Access Compliance Report Public Rights-of-Way (Curb Ramps)

Main Street: CHESNEY_DR Cross Street: LOCH_LOMOND_RD Location: SW

ADA ID: RPAT211201085411 Ramp Type: Type 1 - Perpendicular Diagonal Initial Pass/Fail: Fail Overall Compliance: No Severity Score: 15

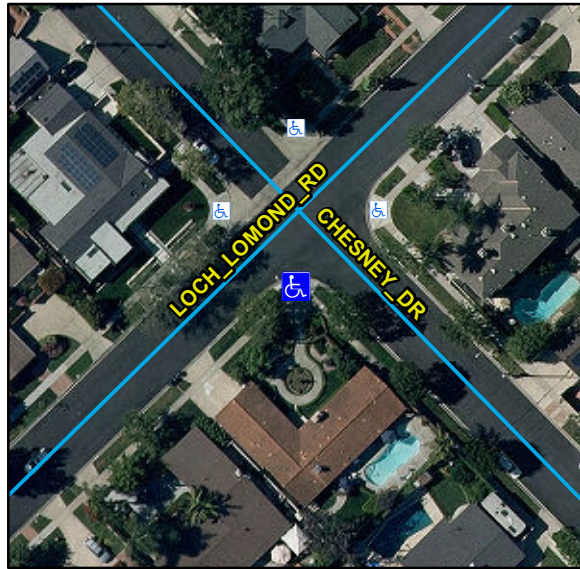
R304.2.2, R204.3, STD 1115

Remove & Replace Curb Ramp With Two New Directional Ramps or Equivalent.
